Product Change Notification (PCN)

PCN Number	505282	Date Issued	February 16, 2018
Reason for Change	Capacity change or tool replacement		
Change Type Description	This letter is to inform you that another set of tooling is being added to meet the current and future demands of this product. There will be no changes in the fit, form or function from the additional tooling when compared to the current tooling.		
Assessment of Change	No change to parts/components FFF		
Internal Molex Qualification Date	June 10, 2018		
Sample Availability Date (Changed Part)	June 10, 2018		
Planned Implementation Date	August 17, 2018		
Method of Identifying Change	Cavity identification

Image of component of finished goods

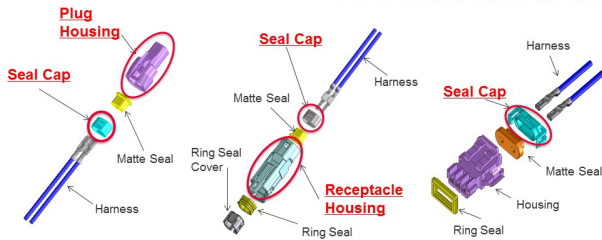
* The red circles are the parts to change.

- Replacement of old molding die replacement and adding molding die due to customer's increasing demand.
- Product Impact
 - no impact to fit, form or function
- Part Number Impact
 - Mizu-P25 series (52213/52266/52117/52116)
 - For details, pls. refer to attached impacted parts list
- Qualification Reports and samples available upon request after the date shown below.
 - Sample : 2018/06/01
 - Qualification Report : 2018/06/20
